lifeboat Initial Inspected Report

SHIP NAME :GRUAUD LAROSE

IMO: 9500807

rescue boat and free fall lifeboat their launching appliances Maker: Jiangsu Jiao yan

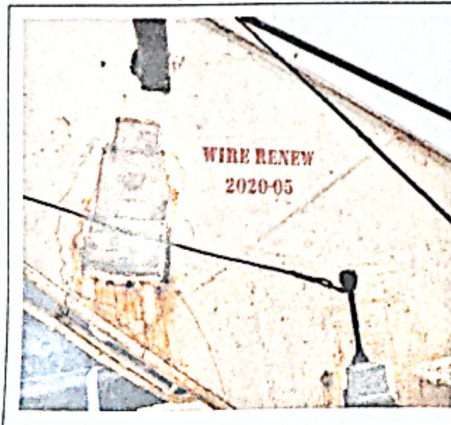
1. 救助艇/尾抛艇浮球浮绳老化换新/Free fall lifeboat and rescue boat lifeline aging --Crew or Services

Crew

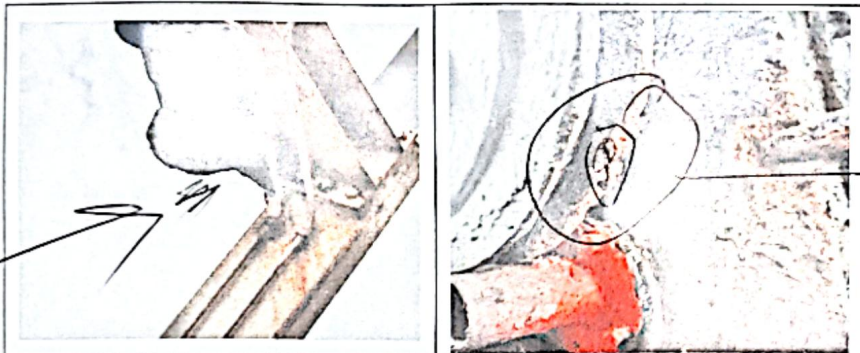
5. 救助艇手摇泵橡皮及排水管老化/Rescue boat hand pump rubber and drain pipe aging

→ check spare
for supply

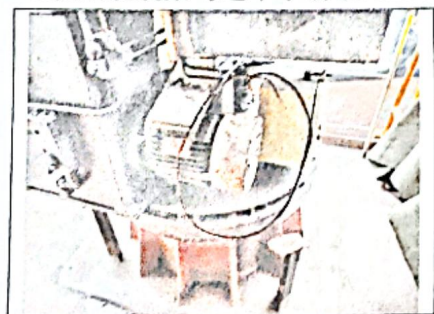
6. 救助艇艇架遥控钢丝及尾抛艇艇架钢丝卷筒锈蚀/Corrosion of rescue boat davit remote control wire and free fall lifeboat drum wire reel

check & change

→ wei'ling
+ 1

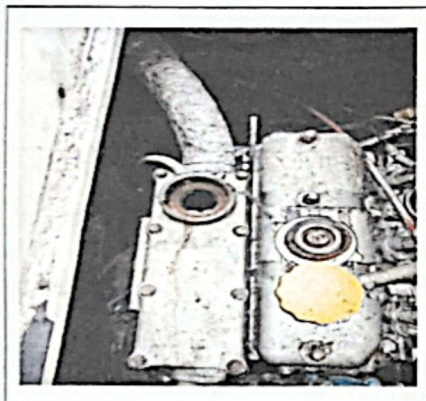
13. 尾抛艇玻璃模糊不清. 需清洁或换新. The free fall lifeboat glass is blurred. Needs to be cleaned or replaced

change gl.

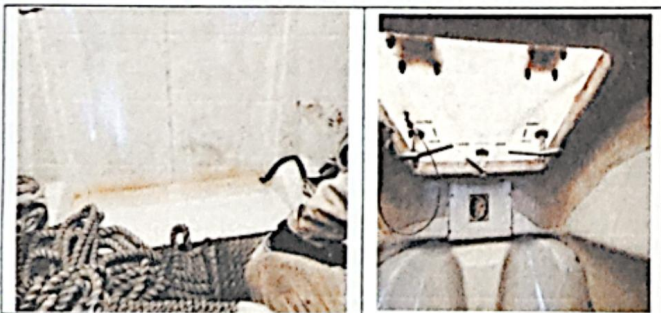
15. 尾抛艇前窗漏水/Water leak in free fall lifeboat launch front window

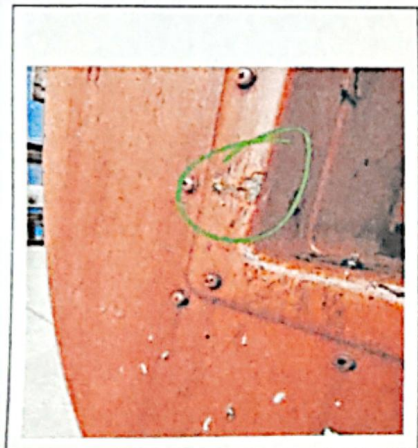
16. 尾抛艇玻璃钢修补./Free fall lifeboat fiber glass repair

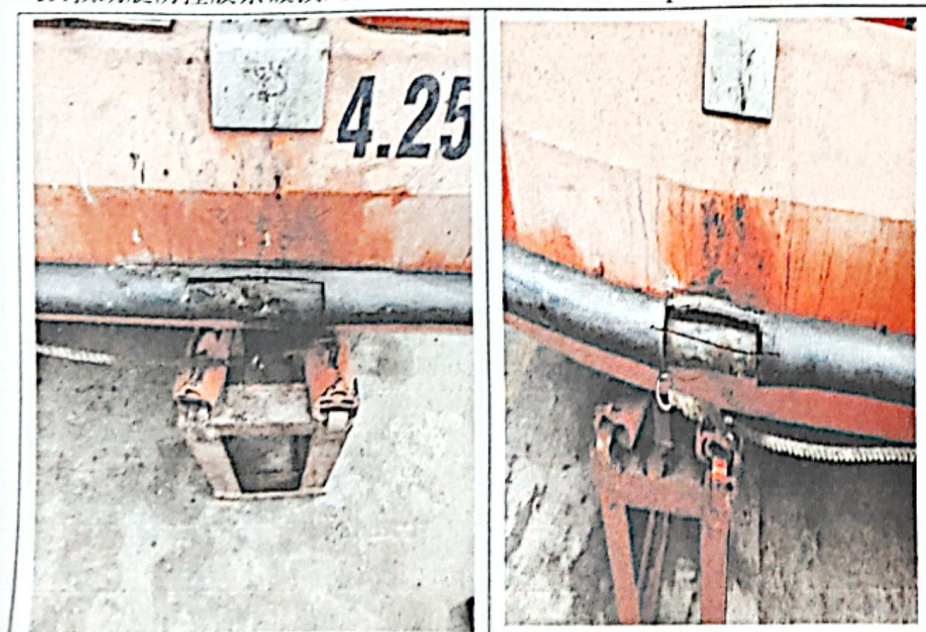
17. 尾抛艇保险钢丝绳及吊艇钢丝前段底座严重锈蚀./Free fall lifeboat safety steel wire connecting base and the front base of the lifting steel wire are seriously corroded.
